SUBJECT Sanitary Sewer for
Lot 17, Block 4,
Briarwood Estates

Briarwood Est.
60-82126-1120
Feb 1, 1985

Re: S/D 79-118 - Final plat of Briarwood Estates

REFERENCE: Drainage Plan

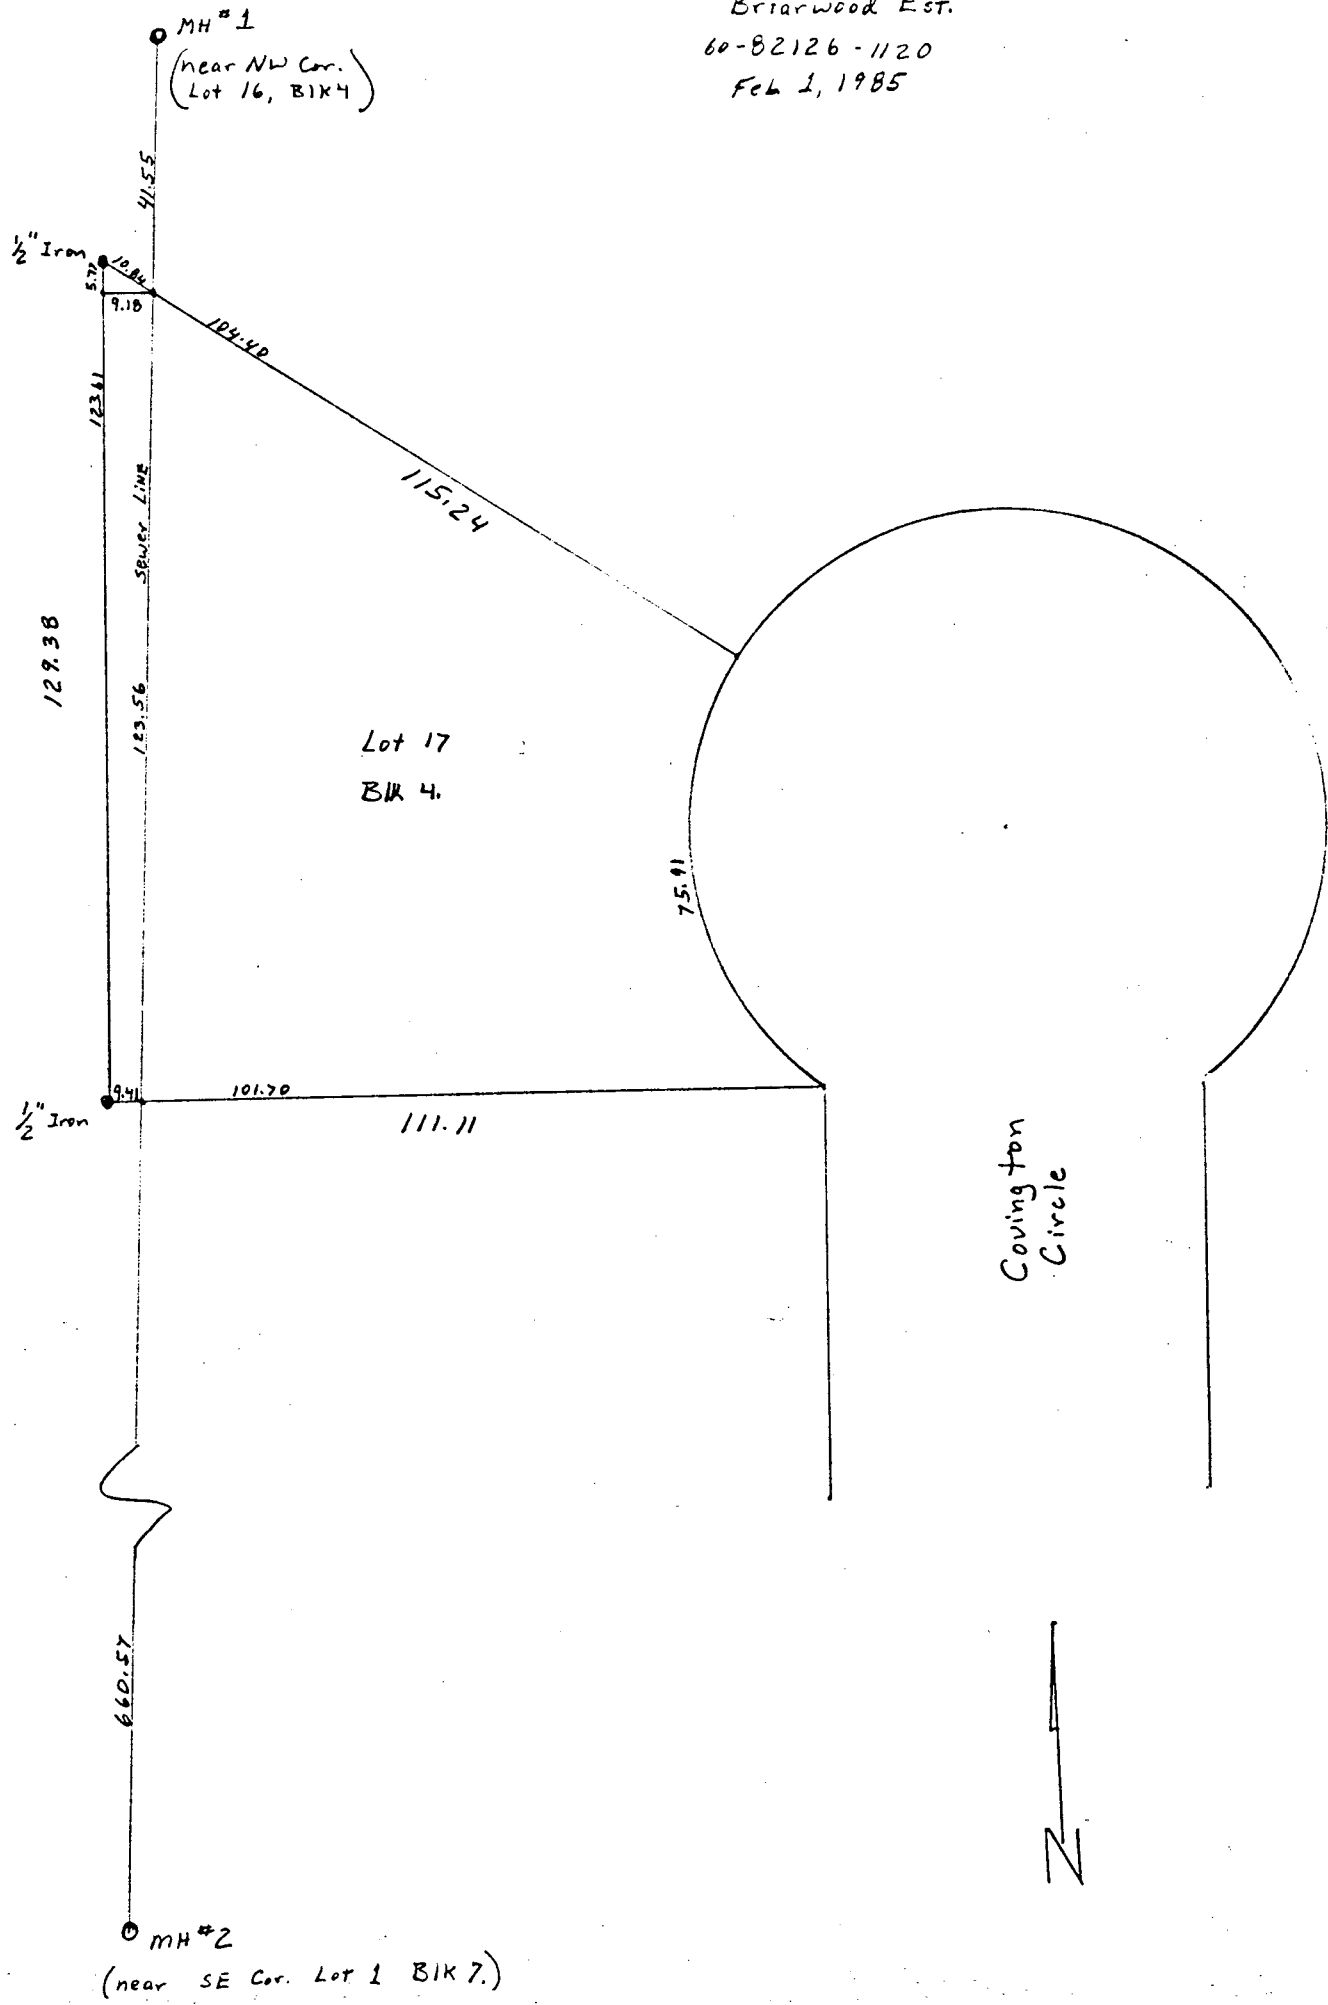
Professional Engineering Consultants has turned in a survey locating the sanitary sewer line at the rear of Lot 17, Block 4, Briarwood Estates.

I have no objection to vacating the east 5' of the 25' easement at the rear of Lot 17.
